Title: Advisory Committee on Nuclear Waste
142nd Meeting

Date: Thursday, May 29, 2003

RESPONSE TO ADVISORY COMMITTEE ON NUCLEAR WASTE COMMENTS ON THE YUCCA MOUNTAIN REVIEW PLAN (YMRP)

Jeff Ciocco, Yucca Mountain Review Plan Project Manager

LICENSING PROCESS FIGURE

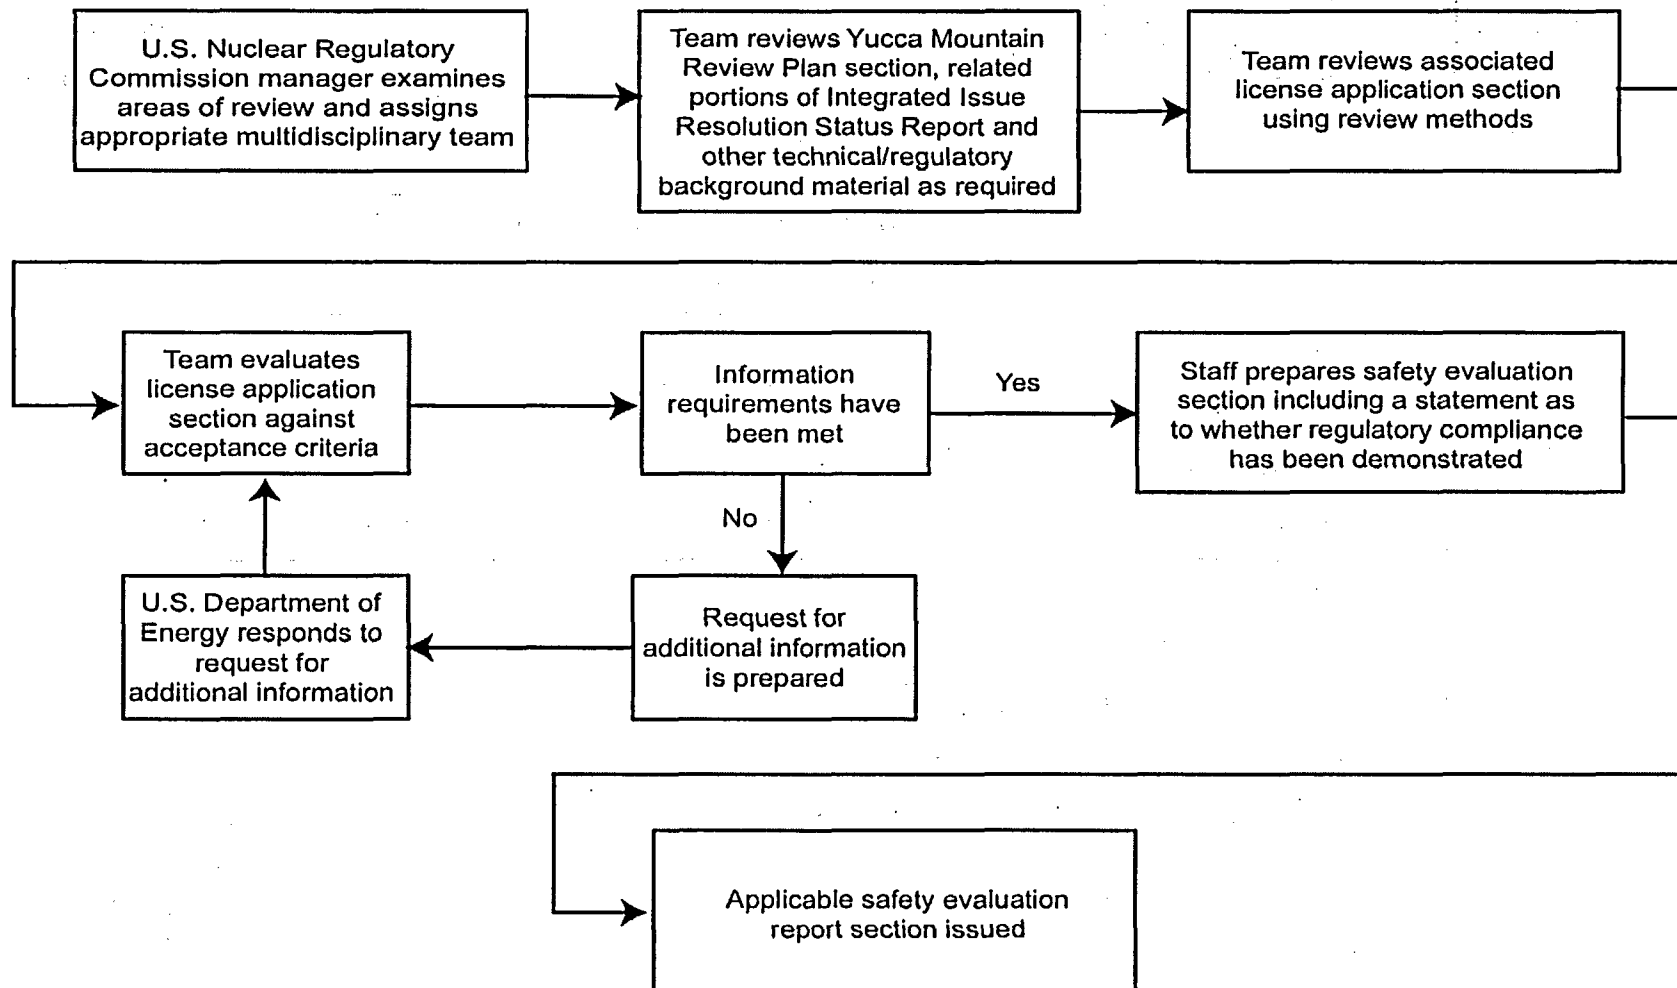
8 And, really, this box should be a triangle
9 because this is a decision point. I think there is
10 actually another block I need to add, and that's in
11 this case, that if there is a complete rejection of
12 the application because it is substantially incomplete
13 or if the staff defined that the license application
14 is sufficiently complete and a detailed technical
15 review could begin down here but additional
16 information is needed in limited areas. That kind of
17 gets you into this loop here.

1 some of these blocks, some of the typical logic
2 shapes, such as a diamond for decisions and what have
3 you, that it would improve it a little.

4 Is there any chance that on the critical
5 blocks, you could indicate a range of time that is
6 involved in order to telegraph the fact that some of
7 these boxes happen, take hours, and some of them take
8 months?

9 MR. CIOCCO: Certainly, yes, yes. And
10 that's a good point. For instance, the acceptance
11 review is a 90-day --

18 MR. CIOCCO: Yes. Actually 18 months to
19 get to the staff's safety evaluation report and then
20 3 years with an optional fourth year to get to the
21 final decision.
